Dear editor,

Comments on HESS-2002-326:

Figure R1. Wavelet coherence between water level and barometric pressure. The thick black contour specifies the 95% confidence level. The arrow directions indicate the relative phase relationship: in-phase pointing right, antiphase pointing left, and phase-leading by 90° pointing straight down.

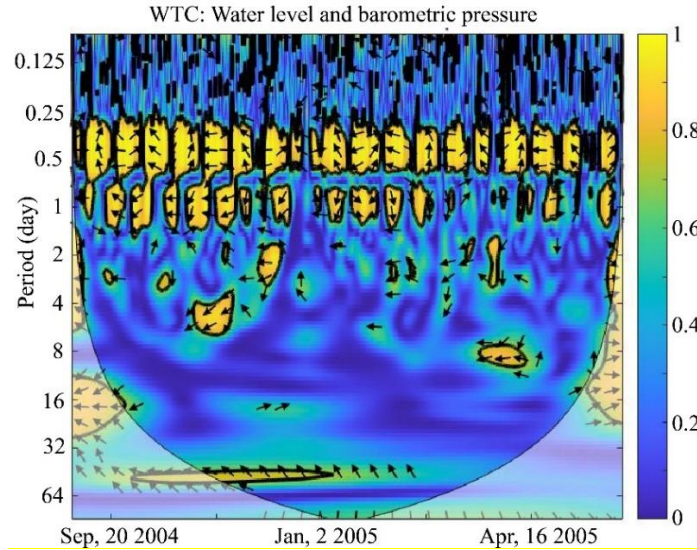
Authors have analyzed water level, flow rate, and water temperature data from an artesian well in southwestern China before and after multiple earthquakes. Water level and temperature showed co-seismic step-like increases following earthquakes. Tidal analysis revealed changes in aquifer and aquitard permeability following earthquakes. Authors coupled the flow rate and temperature data to model the mixing processes that occurred following each earthquake. Results indicate that co-seismic temperature changes are the result of the mixing of different volumes of water from shallow and deep aquifers, with the mixing ratio varying according to each earthquake. I think the manuscript is interesting and suitable for HESS. Resent manuscript should be soon published. Authors thought useful not to consider atmospheric pressure since not monitored at the monitoring site, anyway barometric fields are characterized by large extensions. Authors may decide to ask data to Simao Airport or no, just to evidence relevant eventual variations. In any case present tractation may be considered suitable and convincing.

2.The authors state that there is no barometric pressure record in the well, but could it be possible to get the barometric pressure from nearby place? Sometime the barometric pressure may have large impact on the water level fluctuation.

Response: We collect the monitoring data of barometric pressure in Simao City. In order to identify the effect of barometric pressure on the variation of water level in Dazhai well, the wavelet coherence analysis is employed to explore the correlation between water level and barometric pressure, and then the tidal components of water level in Dazhai well which extracted from the water level signal is compared under and without the influence of barometric pressure. Taking EQ1 as an example to analyze. The hourly monitoring data of water level and barometric pressure from Sep, 1 2004 to May, 30 2005 are chosen for the wavelet coherence analysis and extracting the tidal

The wavelet coherence is used to explore the relationship between water level response to barometric pressure, which is a powerful tool to analyzing nonstationary signals. We convert the time series of water level and barometric pressure into time-frequency space based on the wavelet coherence. In Figure R1, the water level and barometric pressure are highly correlated at a 95% pointwise confidence level with coherence coefficients > 0.9 within band between 0.5 and 1 day. The semidiurnal period is evident throughout the entire data set. Periods of approximately 1 day are slightly unstable. The result of wavelet analysis indicates that the variation of water level is affected by barometric pressure.
